MISSOURI PUBLIC SERVICE COMMISSION

RECOMMENDATION

AMEREN TRANSMISSION COMPANY OF ILLINOIS

CASE NO. EA-2024-0302

Figure 3. Proposed Route DO-28 and DO-27⁷¹

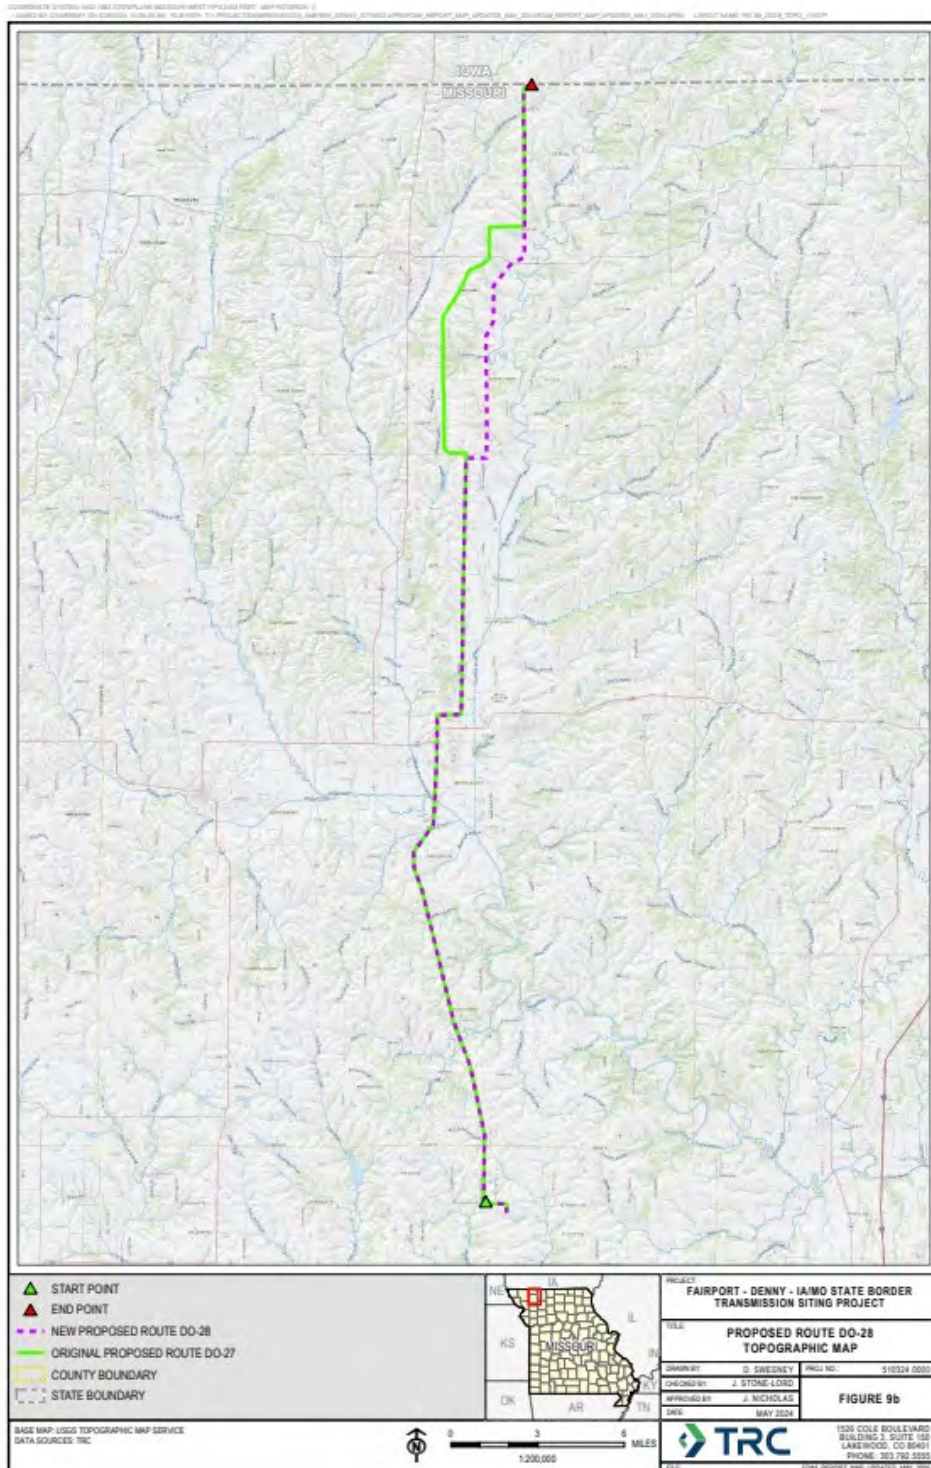
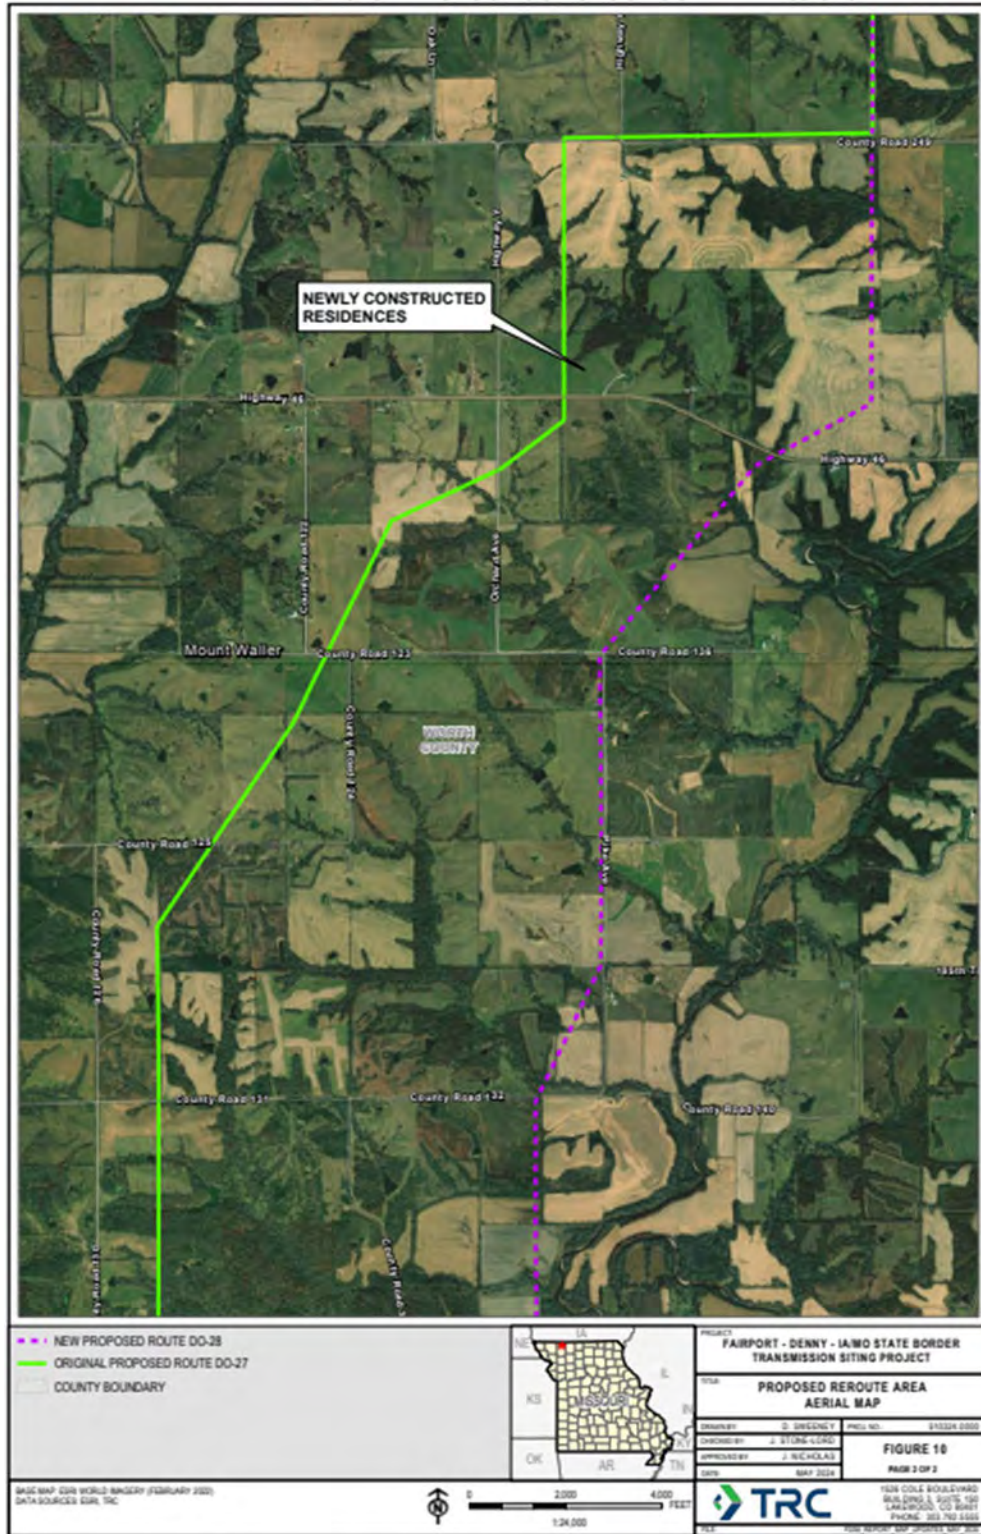
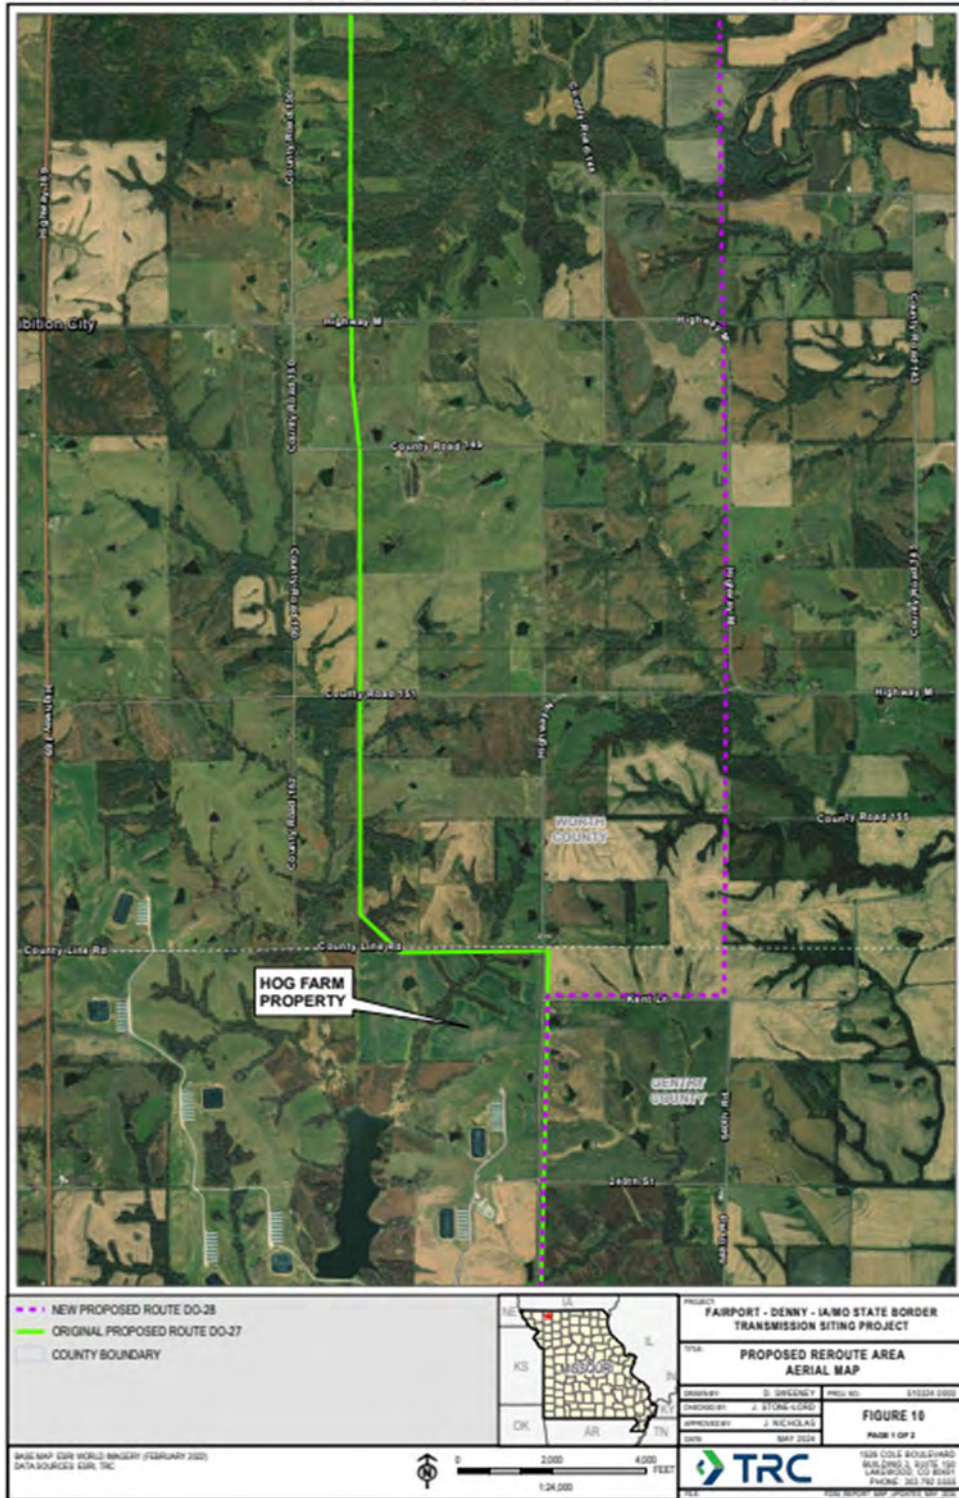
12 DO-27 was a route that was identified as having the overall best score in terms of suitability
13 of the first 27 routes considered. It is Staff's understanding that this route was part of the study
14 area presented at open public meetings hosted by ATXI.⁶⁸ However, as a result of ATXI's public
15 engagement DO-28 was identified.⁶⁹ ATXI represents DO-28 was selected as the proposed route
16 for the FDIM Project on or around May, 14, 2024.⁷⁰ Routes DO-28 and DO-27 are shown in
17 Figure 3. Figures 4 and 5 focus on the re-route area of DO-28 and DO-27 as this re-route area was
18 of significant concern to landowners during the Commission's LPHs.

1 ATXI asserts the routing of FDIM was changed as a result of ATXI’s public outreach
2 efforts.⁷⁴ Originally, DO-27 was the most favorable route of the 27 routes originally considered,
3 but DO-28 is ATXI’s proposed route in its application before the Commission. ATXI discusses
4 the route change in the Direct Testimony of James Nicolas and presents both routes in Schedule
5 JN-D1 (FDIM Route Selection Study, by TRC, dated July 2024). TRC provided three reasons for
6 the route change from DO-27 to DO-28.⁷⁵

6 As previously mentioned, ATXI did not provide notice of the CCN application to
7 landowners along route DO-27. Staff views DO-27 as a known alternative route given that that
8 ATXI discusses the re-route to DO-28 in its direct testimony, presents both options in the TRC
9 routing study, and held open houses regarding a study area encompassing DO-27 and DO-28.⁹⁴
10 ATXI provided notice of the CCN to landowners within 300 feet of the proposed centerline,
11 regardless of whether there is a structure, whereas the Commission rule requires notification of
12 landowners whom an easement would be sought from and those whose habitable structures are
13 within 300 feet.

14 During the virtual LPH, one individual questioned ATXI's re-route to the DO-28 alignment
15 and proposed an alternative route.⁹⁵ Staff previously discussed the re-route on pages 31-32 of this
16 Recommendation. DO-28 (the proposed route) is approximately 1 ½ miles east of DO-27 for
17 approximately 9 ¼ miles.⁹⁶ Thus, if the Commission were to order ATXI to re-evaluate or return
18 to the DO-27 alignment this may create additional frustration and confusion given the landowners
19 along DO-27 were not identified by ATXI as affected landowners and did not receive notice of the
20 CCN application when filed. A reasonable resolution would include additional opportunities for
21 landowners associated with DO-27 to provide testimony to the Commission.
